GAROB DEVELOPMENTS LIMITED

PROPOSED CHANGE OF USE, FROMER CO-OP, WELL STREET, CEFN MAWR, WREXHAM

TN03 – RESPONSE TO LHA COMMENTS

4TH JULY 2023

title
PROPOSED SITE LAYOUT
SWEEP PATH ANALYSIS
FTA DESIGN ARTICULATED VEHICLE

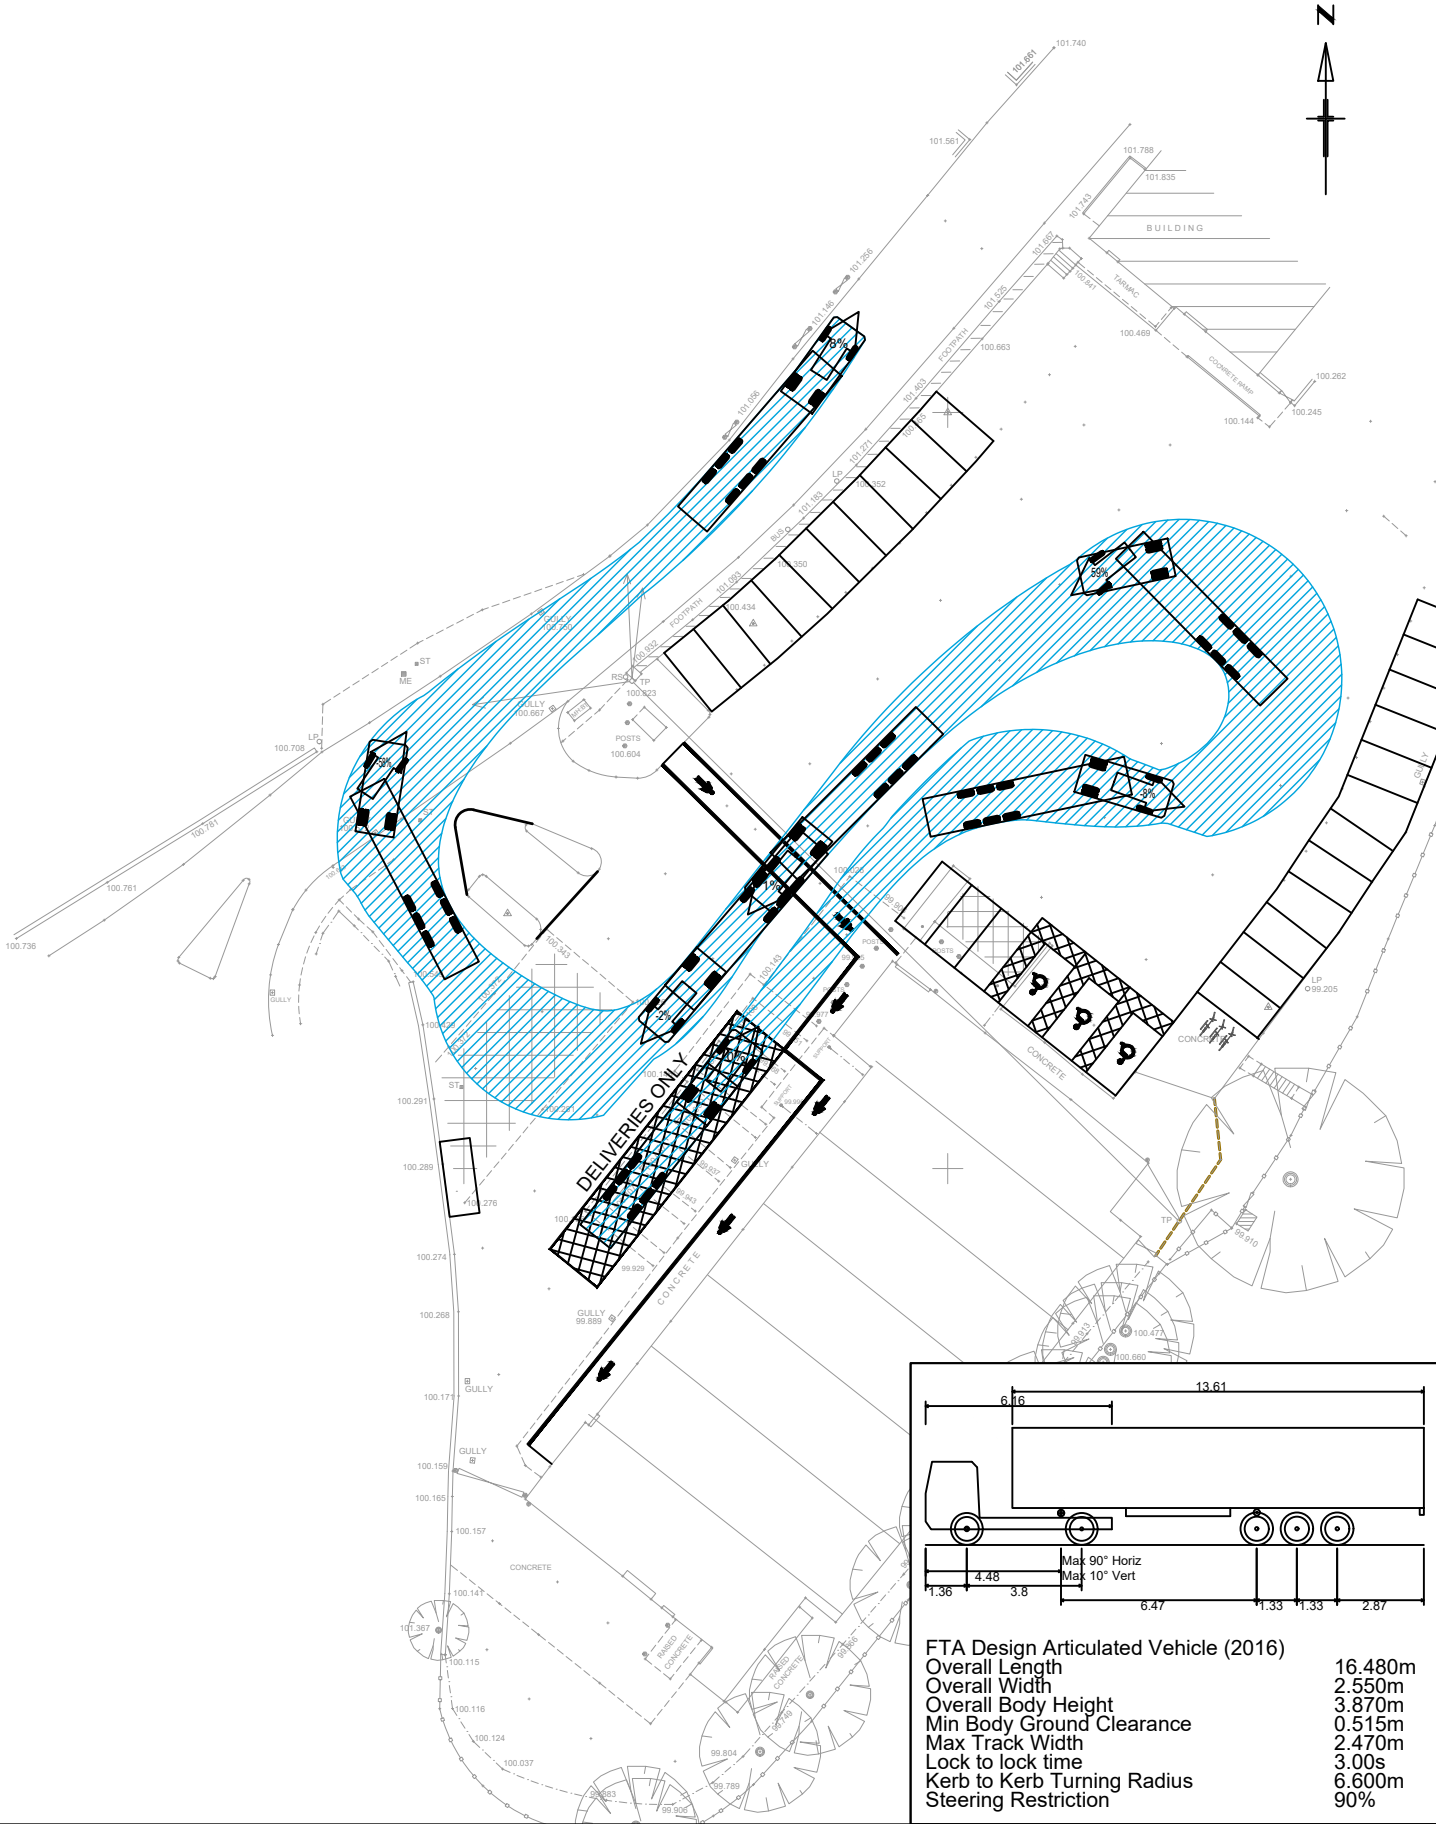
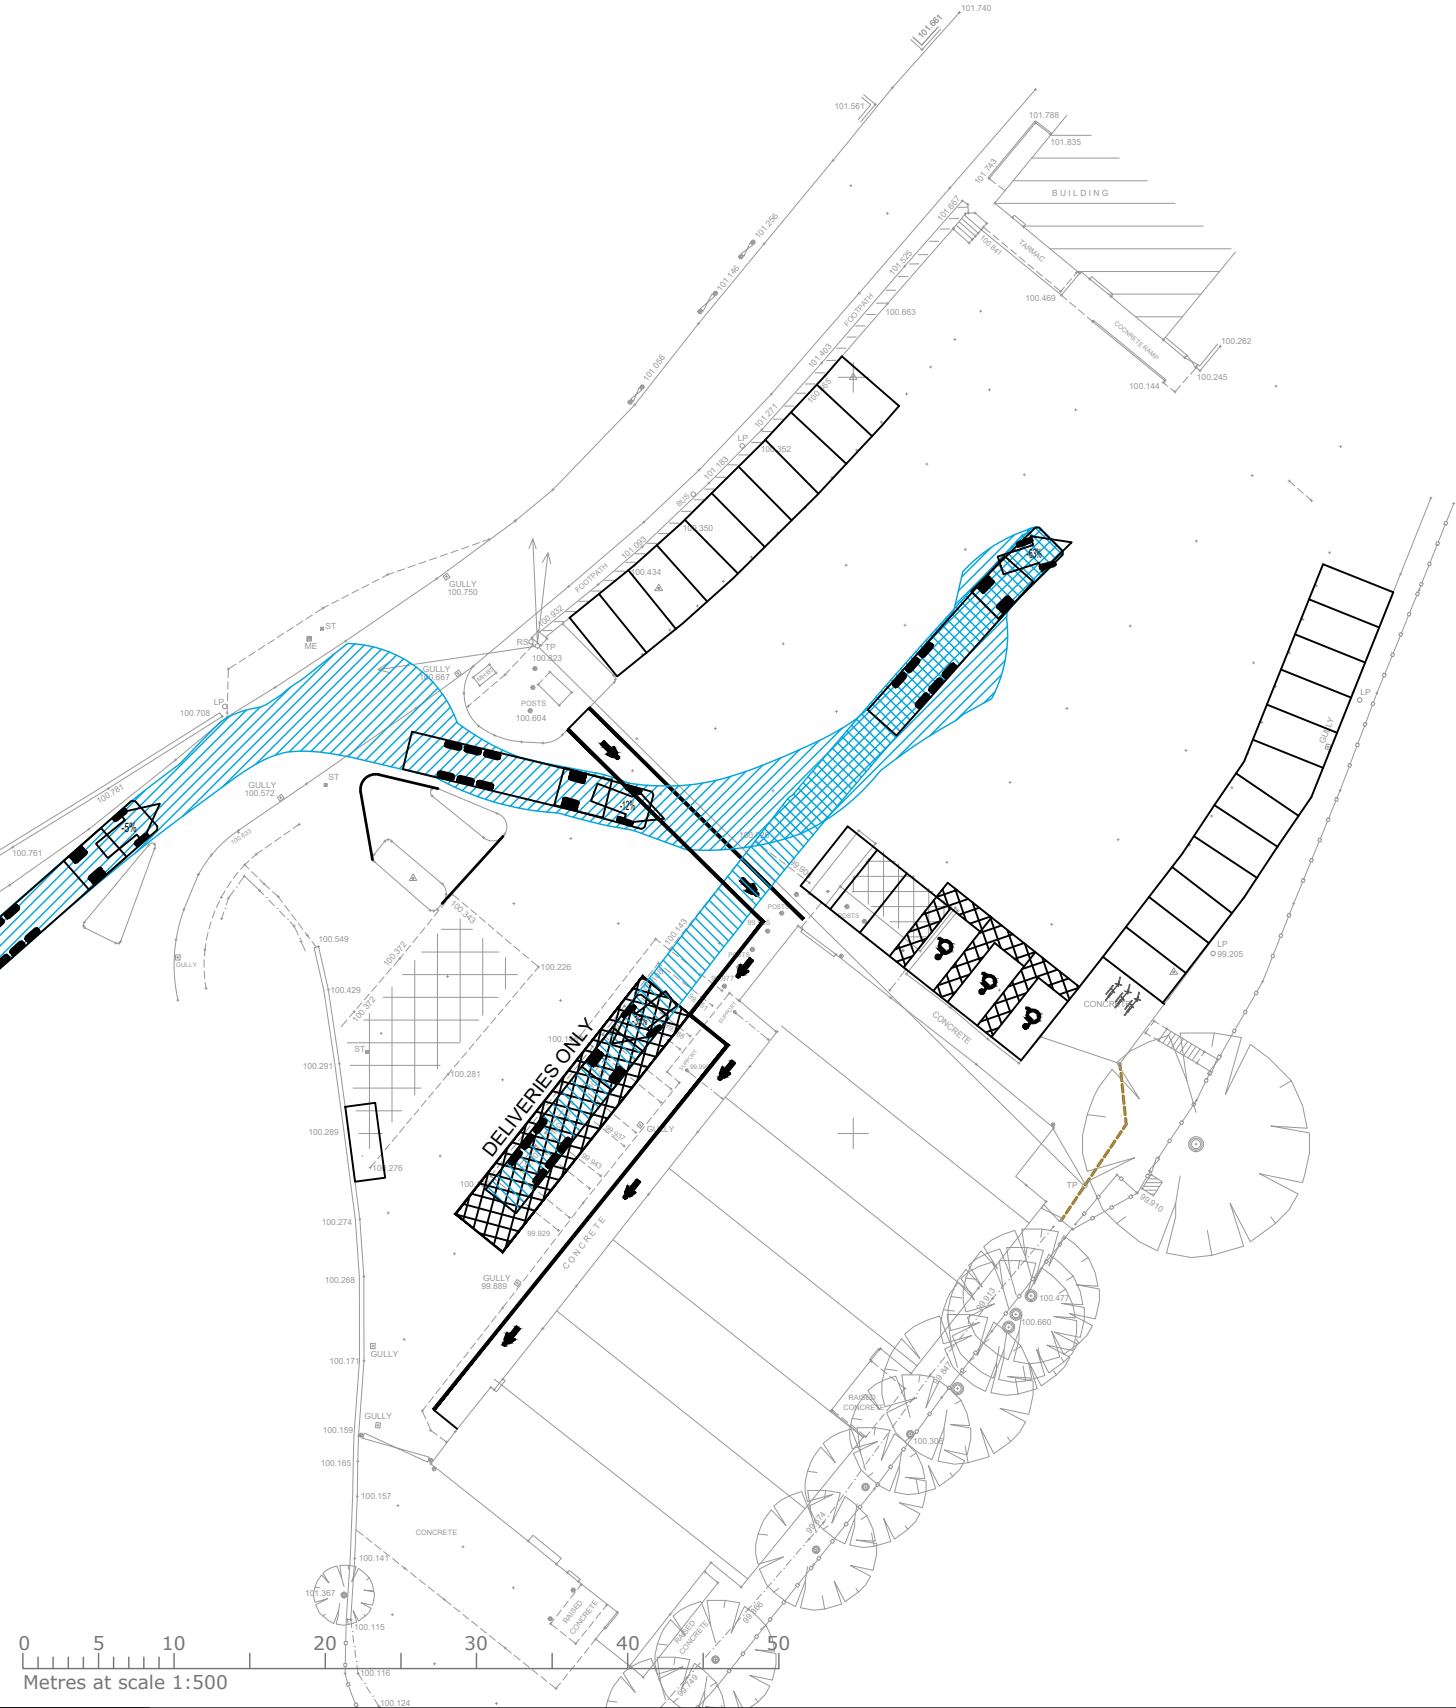
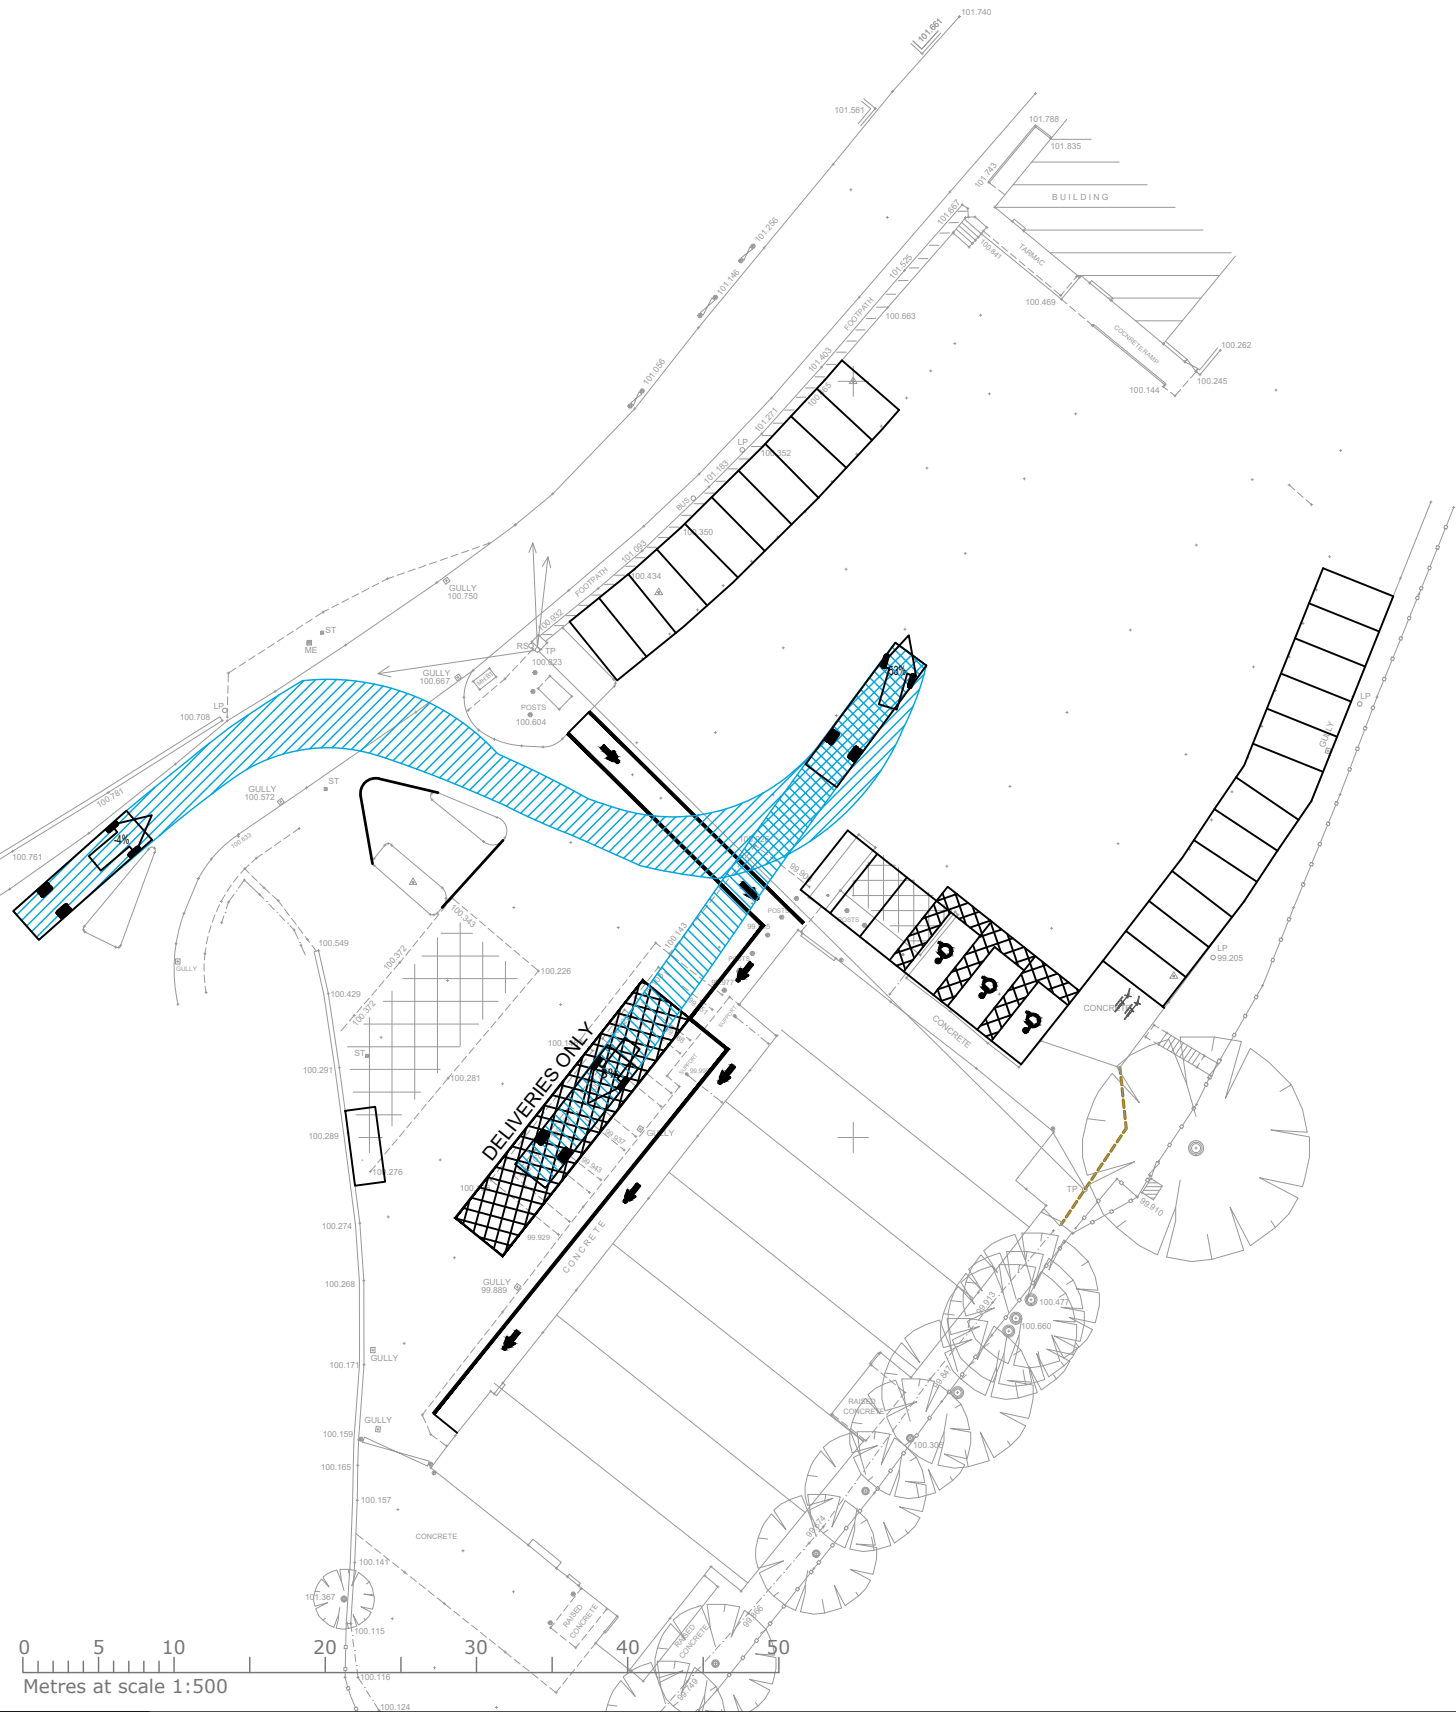
2. Swept path analysis has been provided for both articulated and rigid HGV's both of which are permitted under the current site classification. We note our agreement that adjustment to the central islands may be necessary, which we can agree in due course via a pre-commencement condition as noted below. These alterations may provide central refuge to pedestrian traffic given the size of the opening.

2. Deliveries and servicing of the proposed premises

- 4.6 A marked dedicated delivery and servicing area will be situated fronting the western side of the building. The swept path analysis at Appendix 2 demonstrates that 16.5m articulated and 10m rigid vehicles are able to manoeuvre within the site.
